INSPECTION REPORT
Sedimentation Structure
J16-J
Kayenta Mine
Navajo County, Arizona
for
PEABODY COAL COMPANY

Dames & Moore
10139-011-22

EXISTING
MAXIMUM CROSS-SECTION
A-A'
J16-J

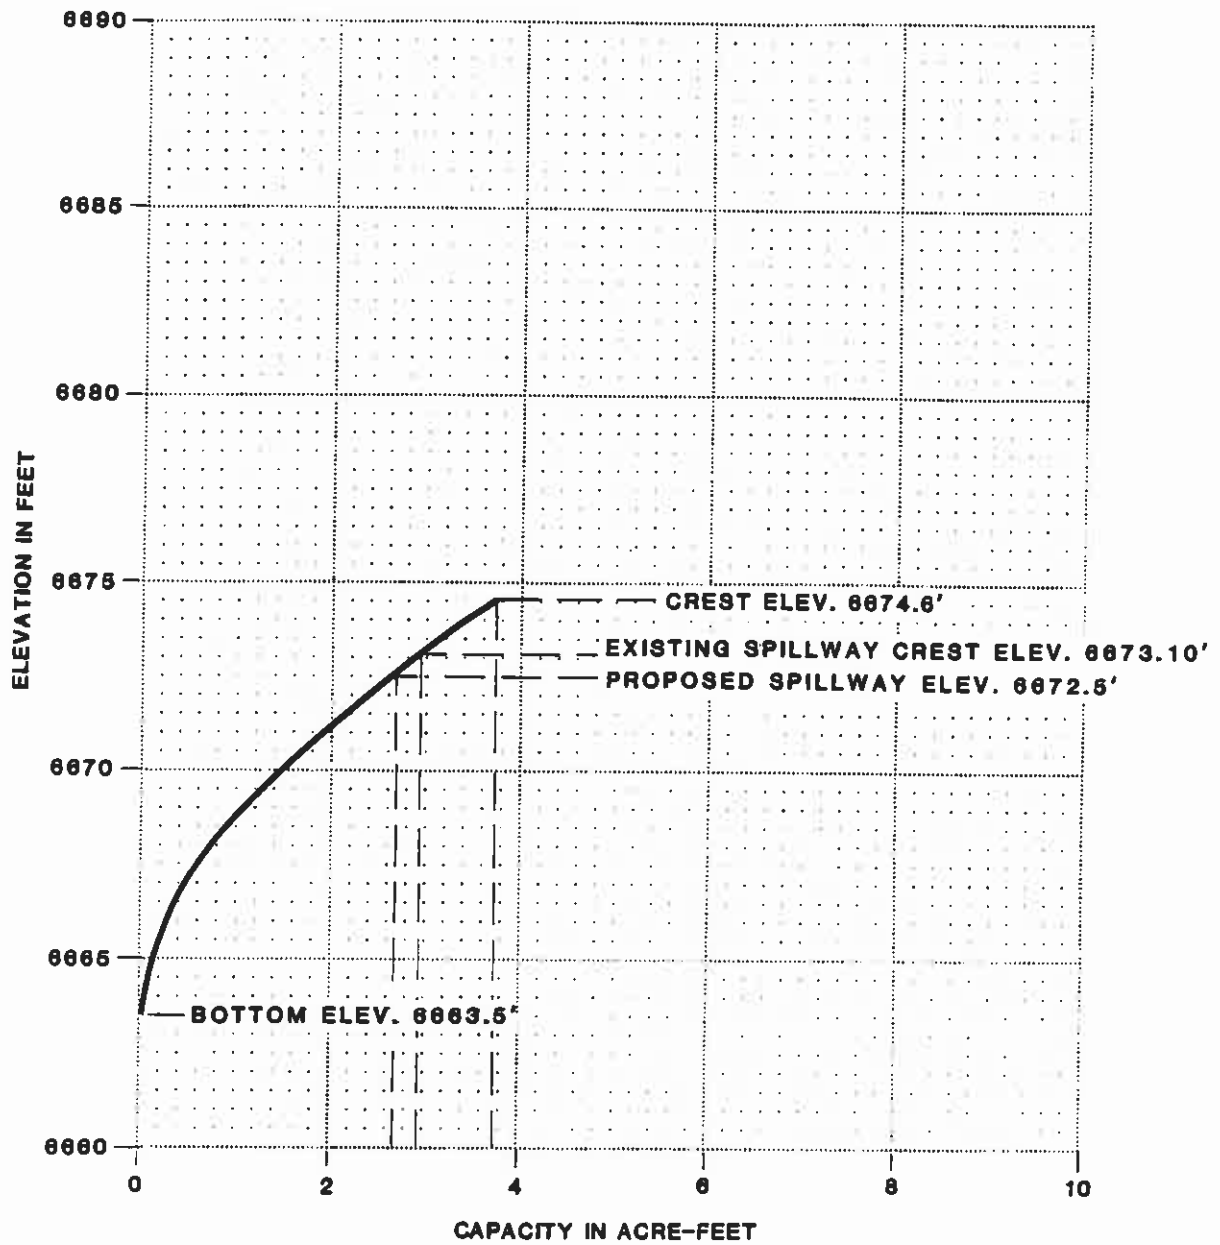
The J16-J embankment is lower in height; however, the foundation slope is greater than 5 percent and the downstream slope is steeper than the category standard; therefore, the embankment has factors of safety less than the design minimum.

The inspection of Structure J16-J indicated that the only geotechnical problem is rill erosion on the upstream and downstream slopes and the side slopes of the spillway channel. Correction of erosion is considered a periodic maintenance task and does not require remedial action.

The downstream slope should be flattened to 3.25 horizontal to 1 vertical to meet stability requirements. This flatter slope was selected due to a foundation slope greater than 5 percent.

**SPILLWAY AND
 OUTFLOW CHANNEL
 CROSS SECTION
 J16-J**

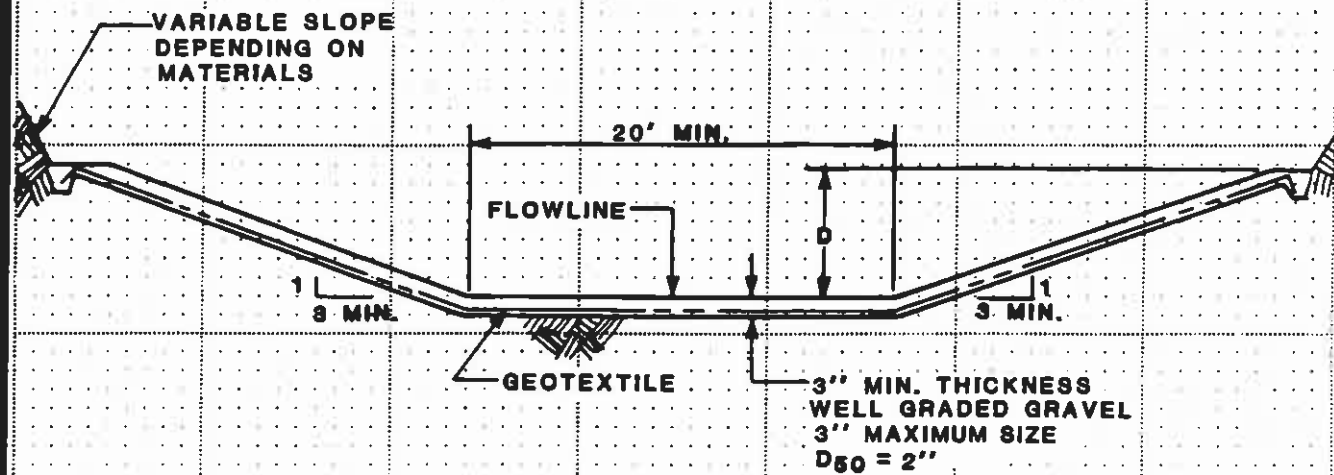
The storage capacity of Structure J16-J is adequate but the spillway capacity is inadequate. The structure does not have an adequate outflow channel. The bottom elevation of the existing spillway channel should be lowered to elevation 6672.5 while maintaining the bottom width of 20 feet as shown on Plate 5. A trapezoidal outflow channel with the same bottom width as the spillway should be constructed along the alignment shown in Plate 1. The channel profile is shown in Plate 4 and required dimensions are shown in Plate 5. Both the spillway and outflow channel should be protected against erosion using geotextile and gravel as shown in Plate 5.

Lowering the spillway elevation to 6672.5 feet decreases the storage capacity and increases the freeboard. The analysis of these conditions is summarized in the following table.
